Subject: PPSSTH-142 - Council Reference RA22/1001

Proposal Demolition of existing structures, removal of trees, construction of two-storey public library building, associated landscaping works and extension of adjacent Council-owned car park

Council provides the following addendum to the submitted assessment report to address matters that have risen since the finalisation of the assessment report and following review of the draft conditions of consent by the applicant. This addendum addresses:

Figure 1: Section Plans

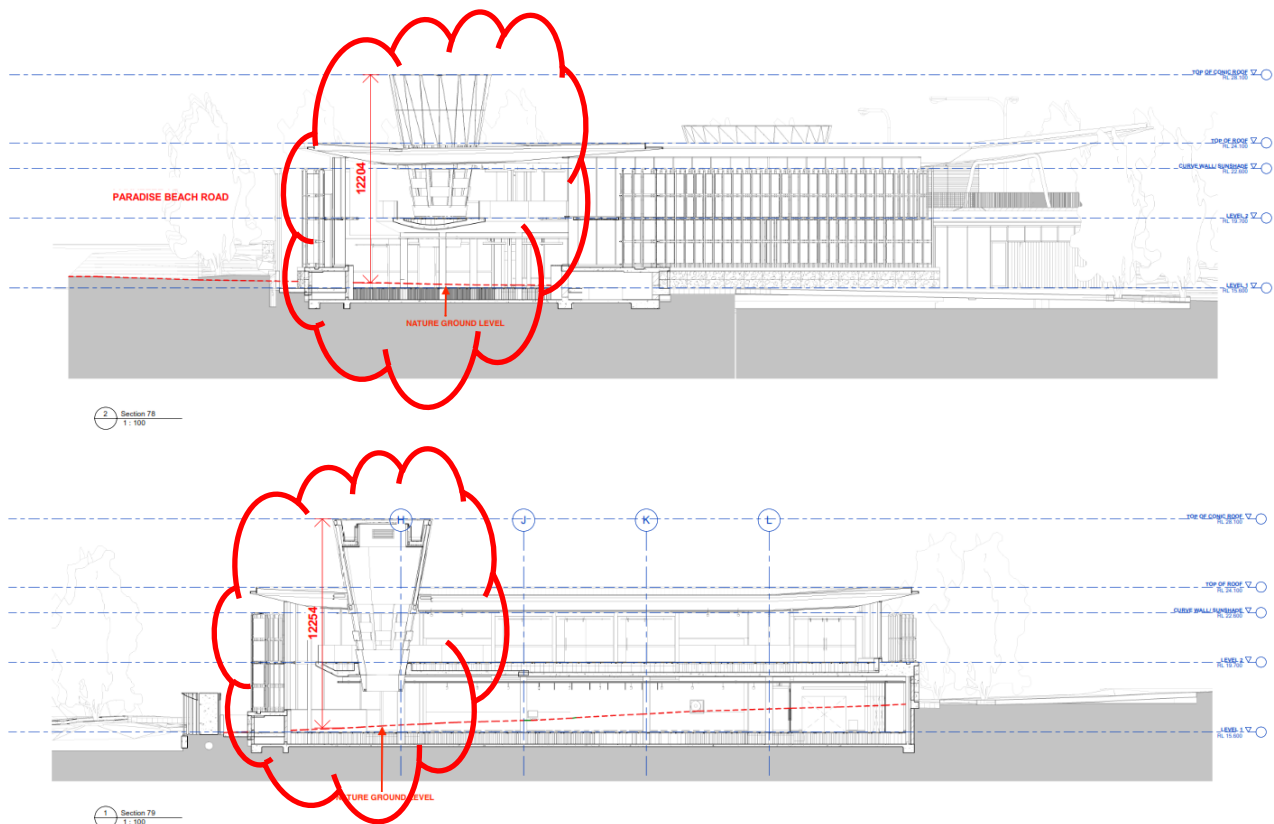
It has been identified that the maximum height of the building in the location of the 'light funnel' exceeds the maximum height control of 11m under section 4.3 of *Shoalhaven Local Environmental Plan 2014* (SLEP 2014) (refer Figure 1). This architectural element is an "architectural roof feature" capable of approval under section 5.6 of SLEP 2014. The relevant provisions of the LEP are addressed below.

<p>5.6 Architectural roof features</p> <p><i>(1) The objectives of this clause are as follows—</i></p> <p><i>(a) to ensure that rooflines, including architectural roof features, respond to and are compatible with the scenic attributes of natural and built environments,</i></p> <p><i>(b) to ensure that rooflines, including architectural roof features, on or in the vicinity of a heritage item or within a heritage conservation area are designed having regard to the heritage values of that item or conservation area.</i></p> <p><i>(2) Development that includes an architectural roof feature that exceeds, or causes a building to exceed, the height limits set by clause 4.3 may be carried out, but only with development consent.</i></p> <p><i>(3) Development consent must not be granted to any such development unless the consent authority is satisfied that—</i></p> <p><i>(a) the architectural roof feature—</i></p> <p><i>(i) comprises a decorative element on the uppermost portion of a building, and</i></p> <p><i>(ii) is not an advertising structure, and</i></p> <p><i>(iii) does not include floor space area and is not reasonably capable of modification to include floor space area, and</i></p> <p><i>(iv) will cause minimal overshadowing, and</i></p> <p><i>(b) any building identification signage or equipment for servicing the building (such as plant, lift motor rooms, fire stairs and the like) contained in or</i></p>	<p>The proposed development includes an architectural roof feature that exceeds the height limit set by section 4.3 and for which consent has been sought.</p> <p>The roof feature is situated on the part of the building that fronts Kerry Street and Paradise Beach Road and comprises a distinguishable roof element of the uppermost portion of the building and has been designed to funnel light into the green wall of the youth area on the first floor of the building (as shown on the submitted section plans at Figure 1).</p> <p>The maximum height of the roof feature is 12.25m as shown at Figure 1.</p> <p>It is considered that the consent authority, being the SRPP, can be satisfied that the architectural roof feature:</p> <ul style="list-style-type: none"> - Comprises an architectural and decorative element on the uppermost position of the building; - Is not an advertising structure; - Does not include floor space area and is not reasonably capable of modification to include floor space area; - Will cause minimal overshadowing. <p>Council has also noted that there is no signage or equipment for servicing the building within the architectural roof feature.</p> <p>Accordingly, the proposal is recommended to be supported.</p>	<p>Yes</p>
